To: T10 SAS Protocol Working Group

Subject: SAS 2.0 : 08-216 Retry to Open Limit timer fix

Overview

Figure 118 — Port layer examples

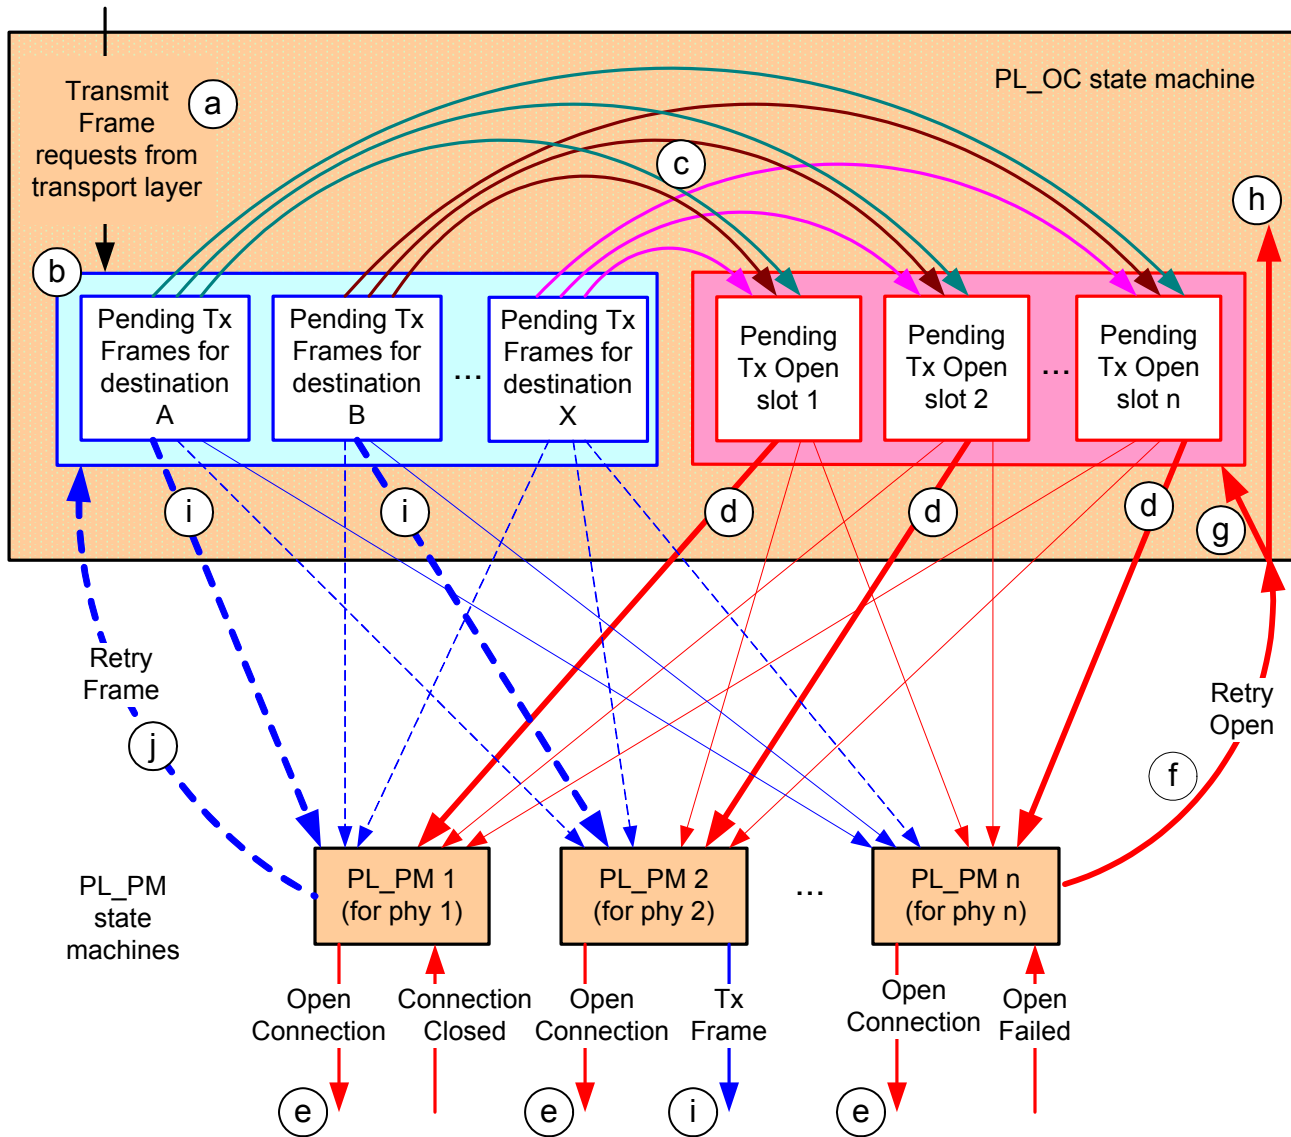
- the PL_OC state machine generates a pending Tx Open message for a pending Tx Frame message when there is a pending Tx Open slot available (i.e., the number of pending Tx Open messages is less than or equal to the number of **phys-destination addresses**);

- g) ~~after the Reject To Open Limit timer, if any, has expired, and~~ if there is a pending Tx Open slot available, then the PL_OC state machine converts a Retry Open message to a pending Tx Open message with the pathway blocked count and arbitration wait time context from the Retry Open message applied to the pending Tx Open message, and may start the Reject to Open Limit timer;

Editor's Note 1: The original wording above indicates the intention of the Retry Open being converted to a pending Tx Open after the timer expires.

Conceptually, this proposal changes the pending Tx Opens from being a one-per-logical-phy structure to a (at most) one-per-destination-address structure.
